MODIFICATION RECOMMENDED

81134A-01

S E R V I C E N O T E

81134A- High Speed Pulse Generator

MOTHERBOARD
BACK SIDE VIEW

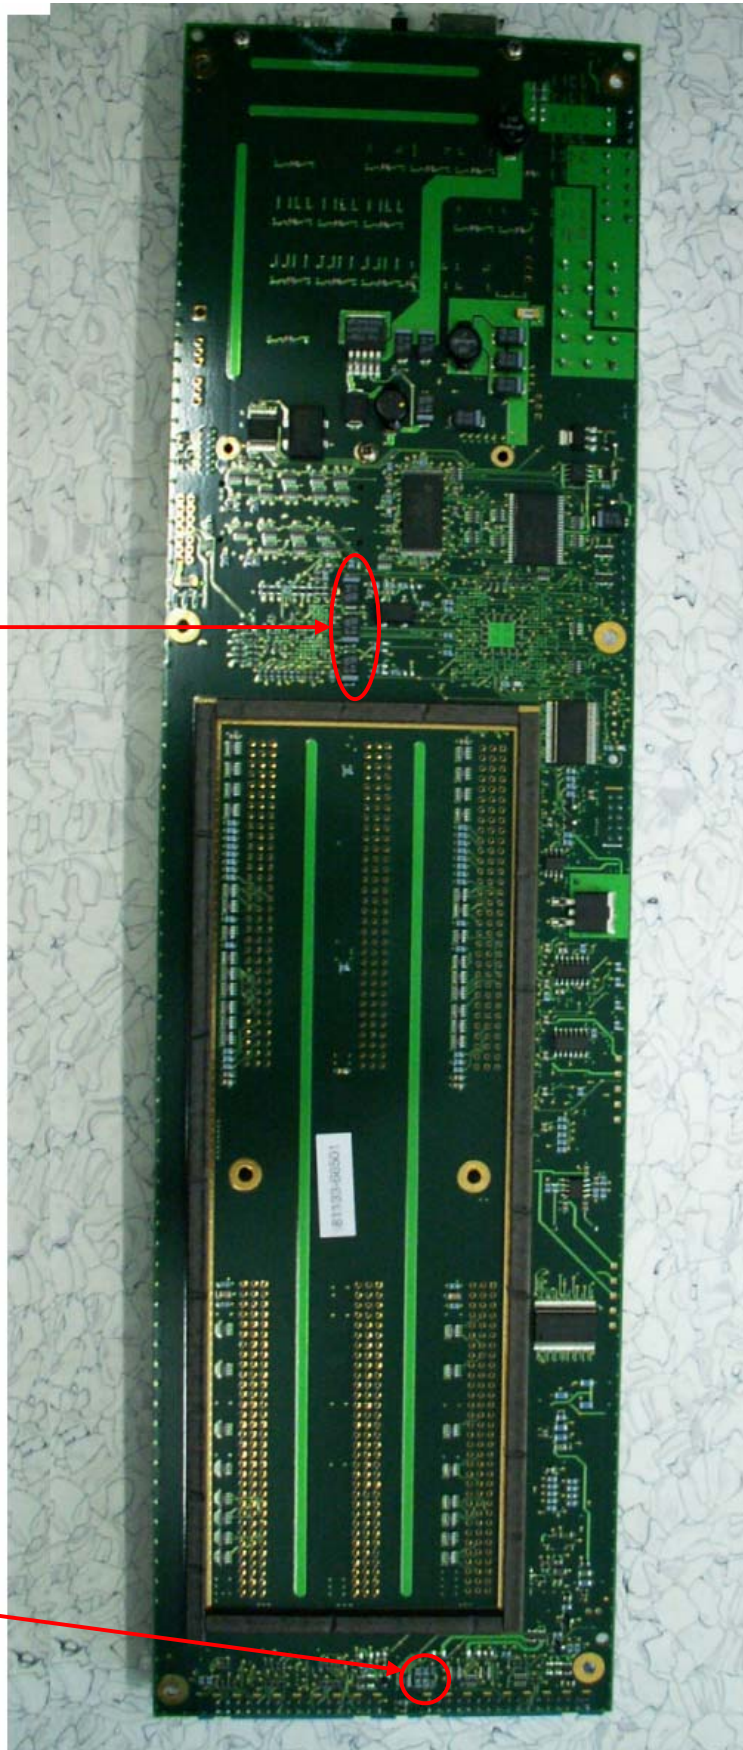
The preventive maintenance to avoid flickering display failures requires removing the 3 capacitors shown in the following picture and replacing them with new capacitors (part number 0180-4758) while mounting them with the correct polarity.

Polarized Capacitors

Extra Resistors

The capacitors are best removed using hot air. The new capacitors need to be mounted using standard soldering equipment.

CLOSE UP VIEW WHERE THE CAPACITORS ARE LOCATED

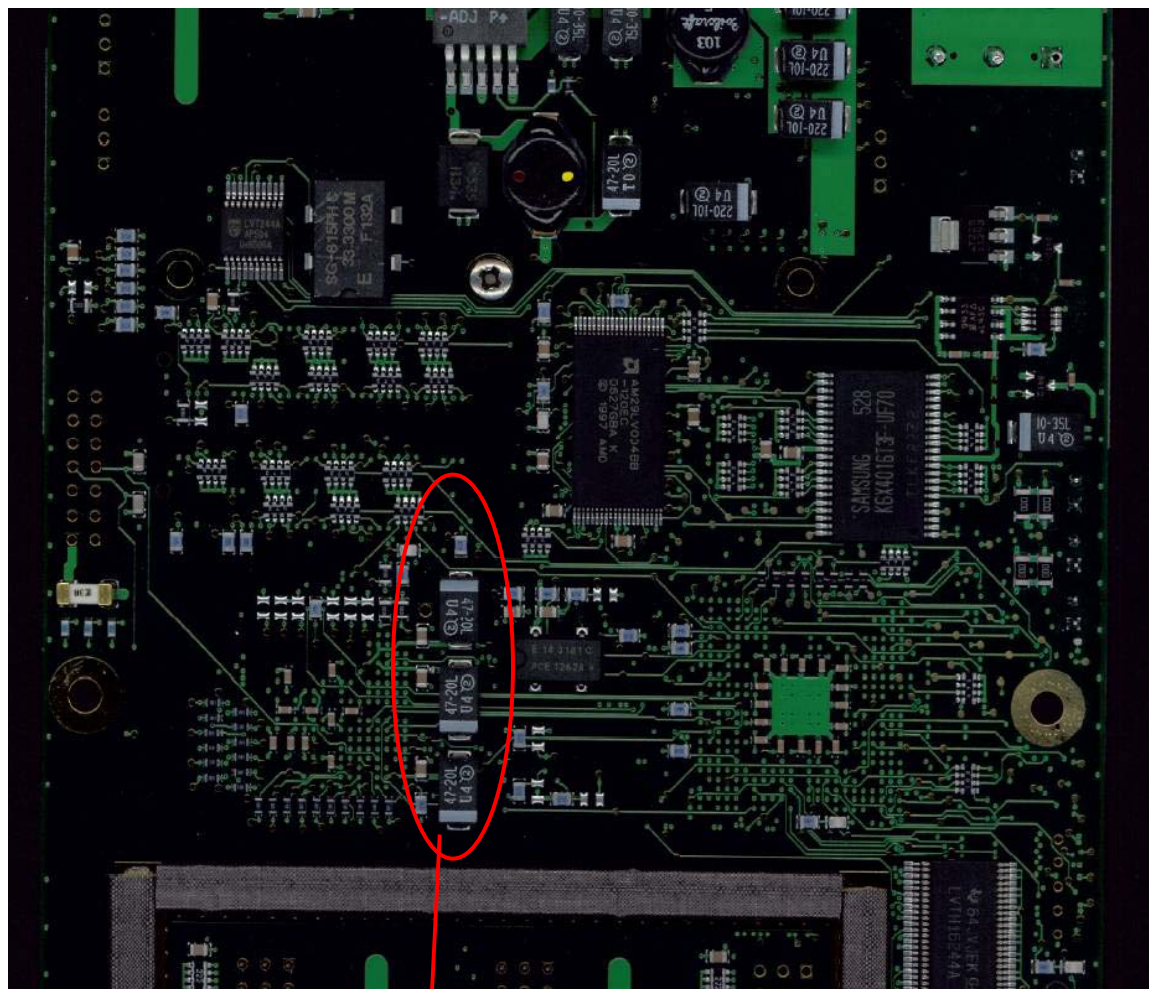
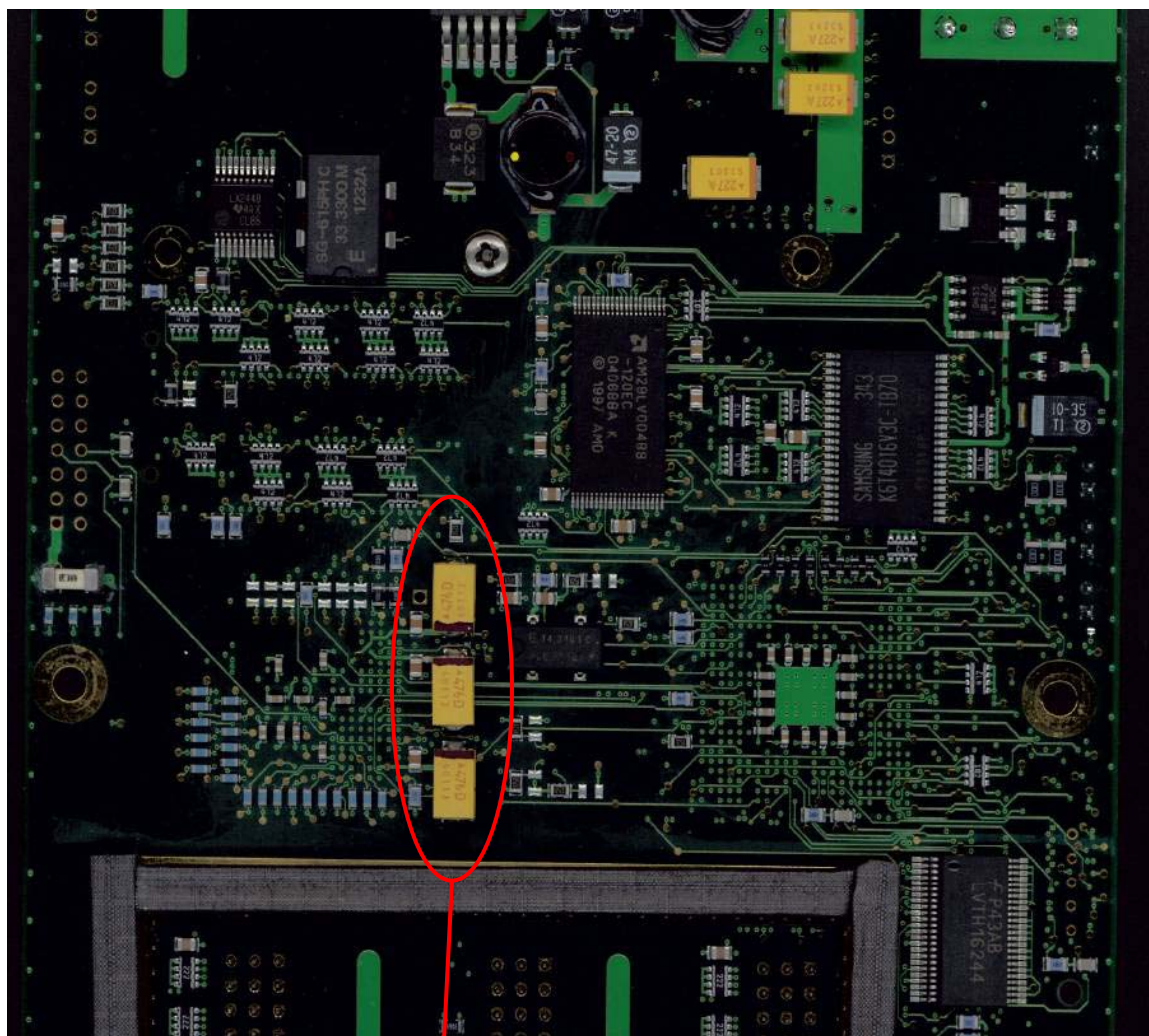
Three polarized tantalum capacitors on the motherboard are connected with the wrong polarity. The polarized tantalum capacitors are normally more sensitive than others, so they tend to fail after some months. Due to this, wrong voltages were delivered to the front panel board which in turn affected the display.

Capacitors mounted with the wrong polarity. The positive side is shown with the white/grey stripe. These 3 capacitors need to be removed.

By applying new capacitors and mounting them with the right polarity failures can be prevented for the future.

This photo shows the capacitors mounted with the right polarity. The positive side is shown with the black stripe. The colors might vary.

CLOSE UP VIEW – THE RESISTORS ARE REMOVED

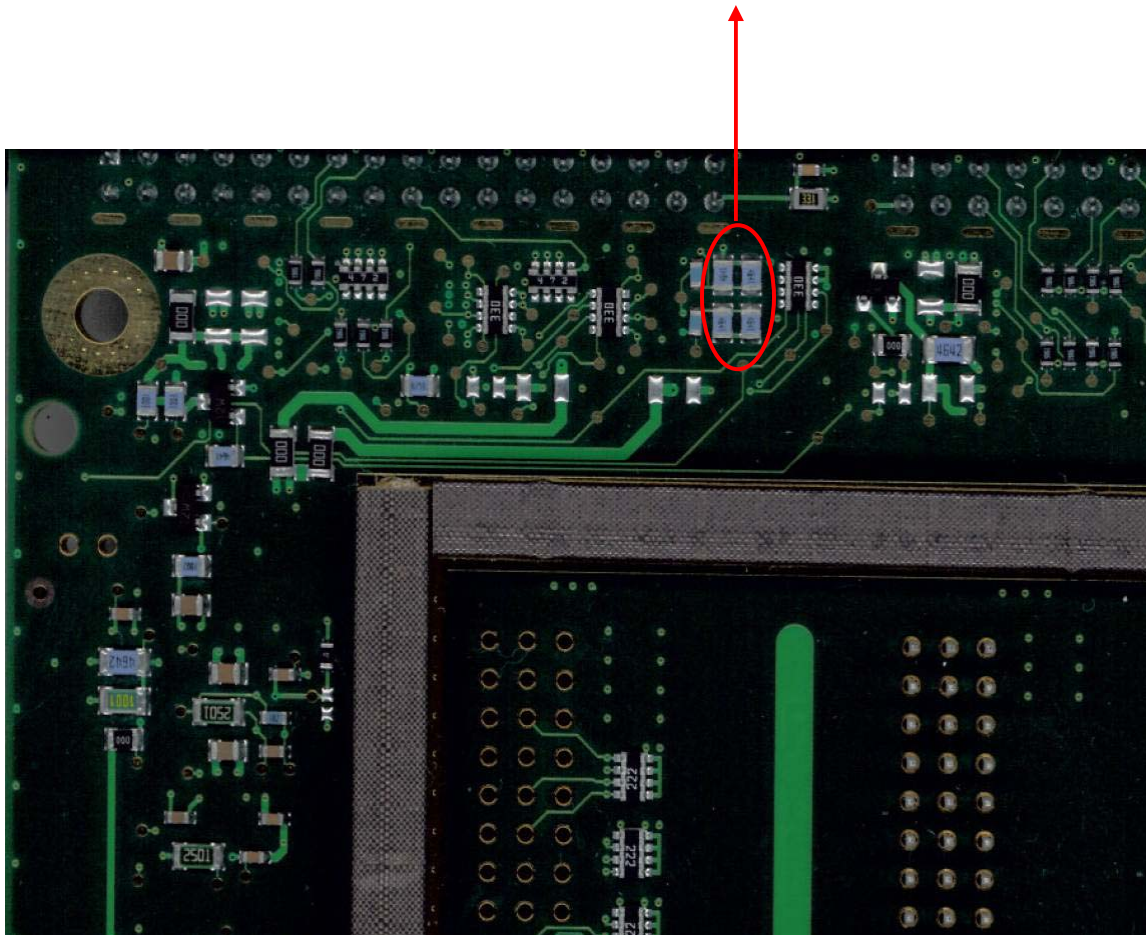
The rotary encoder (APN 0960-1055) has failed in some cases due to incorrect pull up resistance of the encoder. The pull-up resistance of this encoder as specified by the manufacturer is minimum 2.2 K Ohms. According to the schematic of the front panel in the 81134A, the pull-up resistance used was 1.5 K Ohms. The lesser resistance value had possibly led to the flow of more currents into the encoder and had degraded the performance of it over a period of time.

For the preventive maintenance of the know problem the following 4 resistors need to be removed. They are best removed using hot air.

Resistors to be removed (The colours can be different)

By removing a few parallel resistors the resistance can be increased, preventing failures of the rotary encoder in the future.

The place where the 4 resistors are removed
